## Determination 2017/039

# Regarding the refusal to issue a code compliance certificate for a 15-year-old house with monolithic cladding at 2D MacMaster Street, Richmond, Invercargill

**Figure 1: The development**

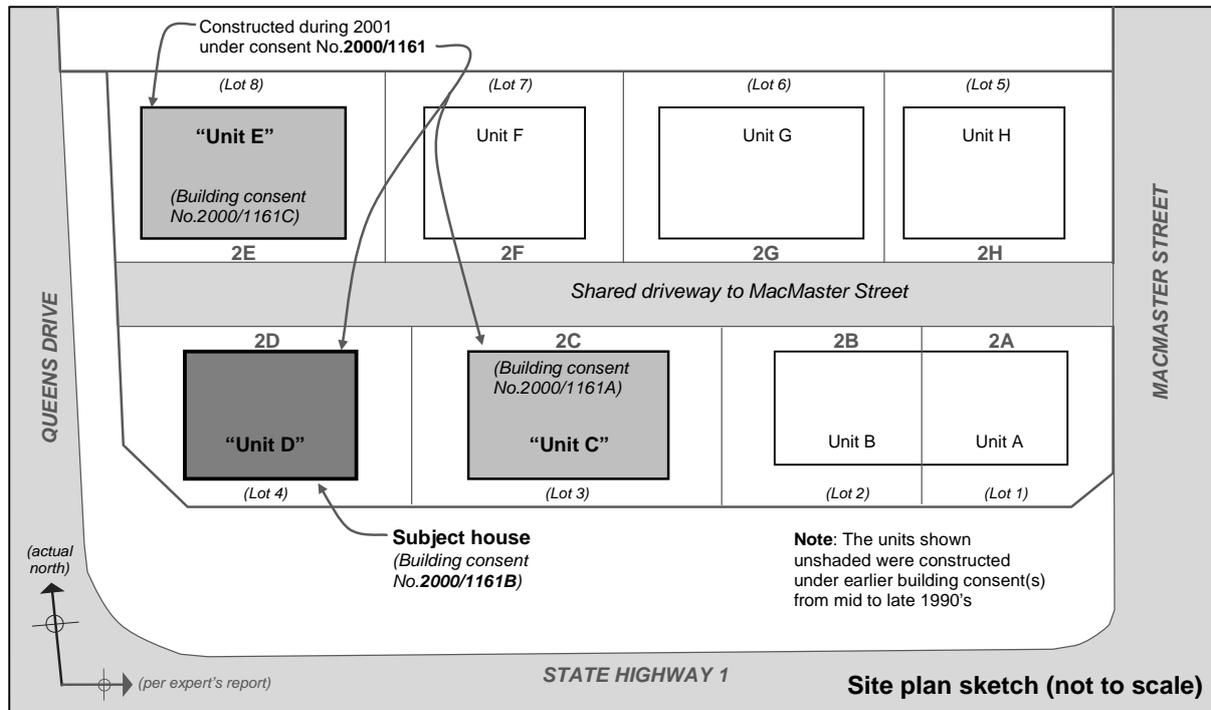
2.1.2 In his report, the expert took the garage door of Unit D as west-facing, but the drawings and actual orientation of the development show the driveway to the north of Units A to D as shown in Figure 1, and the authority's inspection records for Units

C to E use the latter orientation. Because all records identify Unit D as the southwest unit, I have taken the garage door of Unit D as north-facing.
